CLEVE HILL SOLAR PARK

ENVIRONMENTAL STATEMENT
VOLUME 4 - TECHNICAL APPENDIX A17.2
NATIONAL GRID CONSULTATION

Ref: EN010085 - Cleve Hill Solar Park

PROJECT: Cleve Hill Solar Park TITLE: Safety Clearance Elevations DATE: 19.09.18 SCALE: Various DRAWING NO.: 2238-DR-LAN-301

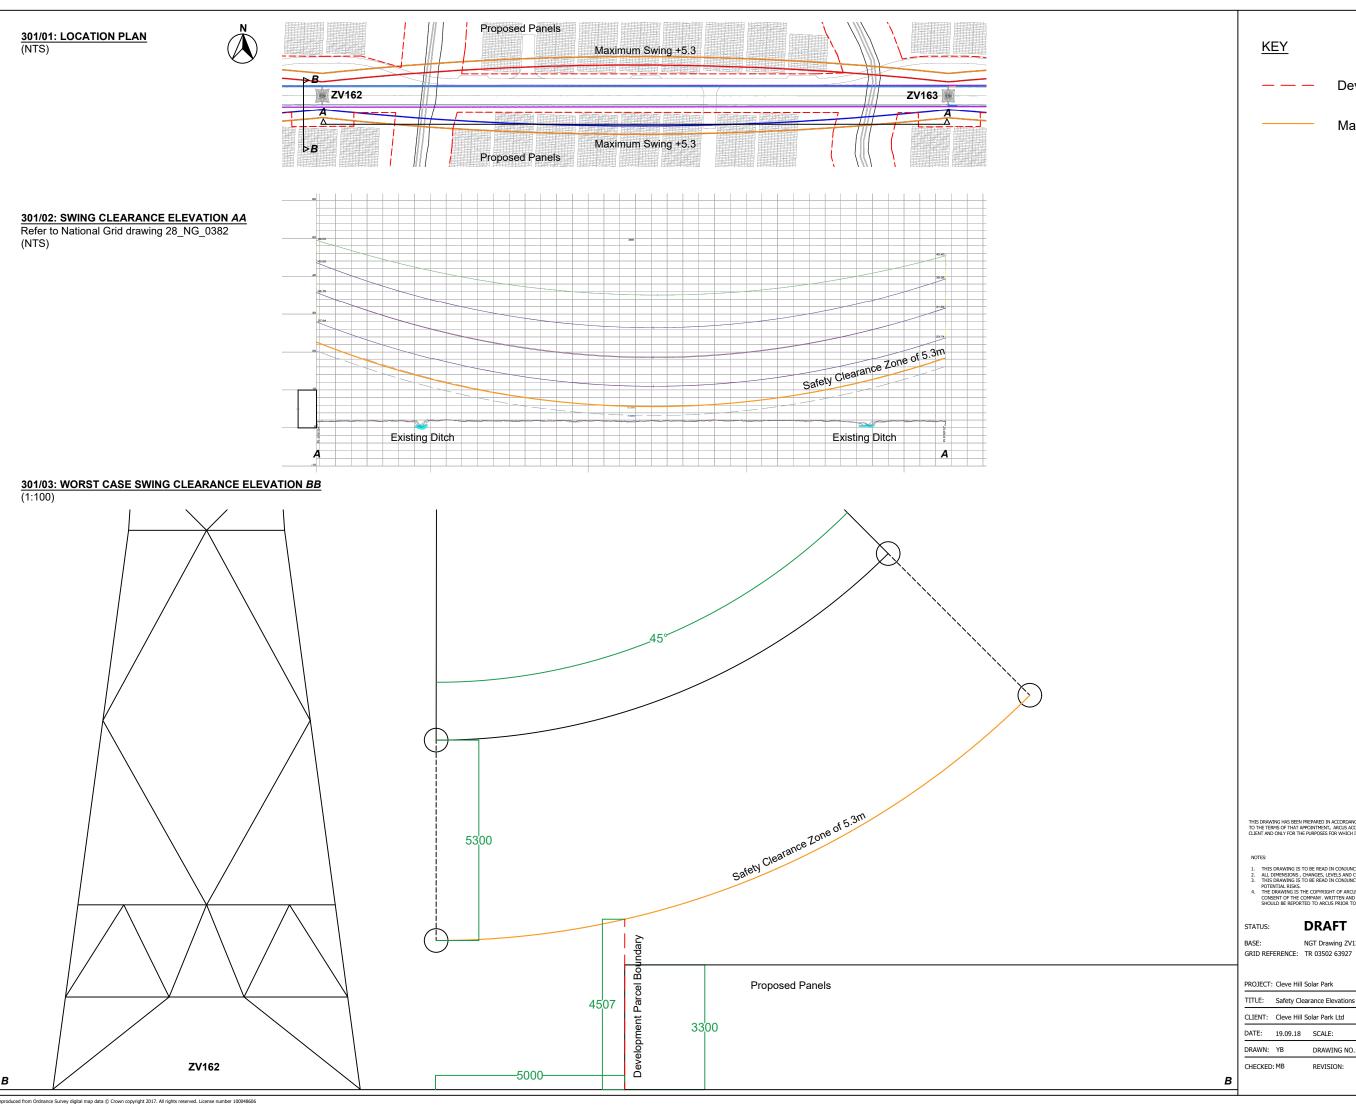
We have reviewed the documentation that you have sent over, including NGET Section Clearances, and are satisfied that NGET is comfortable with your design approach at this stage.
